Bulletin No. 2003-14

Crankcase Oil Entering the Breather - 25 Four Stroke

Model	Serial Number or Year
MERCURY/MARINER 25 HP Four Stroke	S/N 0G590000 through 0T549806 1998 through 2002

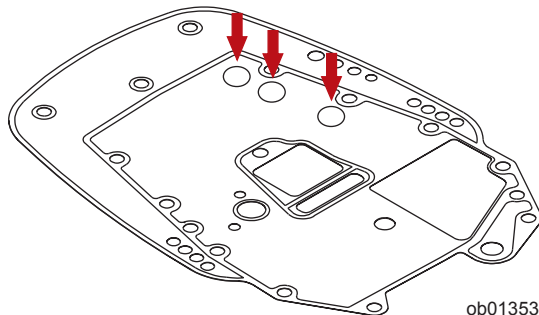
Check that the recommended engine operating range at wide open throttle (WOT) is 5500 - 6000 RPM. Engine speed should not exceed 6000 RPM. Reduce the WOT RPM by installing a higher pitch propeller.

New driveshaft housing to adaptor plate gasket (27-825251--7)

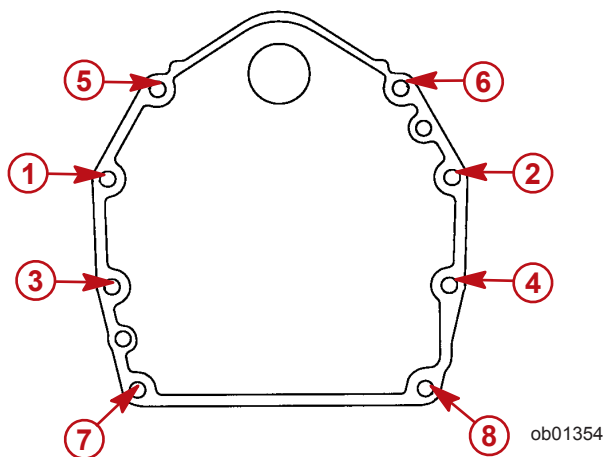
For engines in which the WOT RPM is correct, it is necessary to install a new gasket between the adapter plate and the driveshaft housing. Replacing the gasket requires the removal of the powerhead and the adaptor plate, replacement of gaskets above and below the adaptor plate, replacement of the eight powerhead bolts, and replacement of the five adaptor plate to powerhead bolts.

It is very important to tighten the bolts to the correct torque and in the correct sequence.

Description	Nm	lb. in.	lb. ft.
Driveshaft Housing to Adaptor Plate Bolt Torque - Dry	38		28
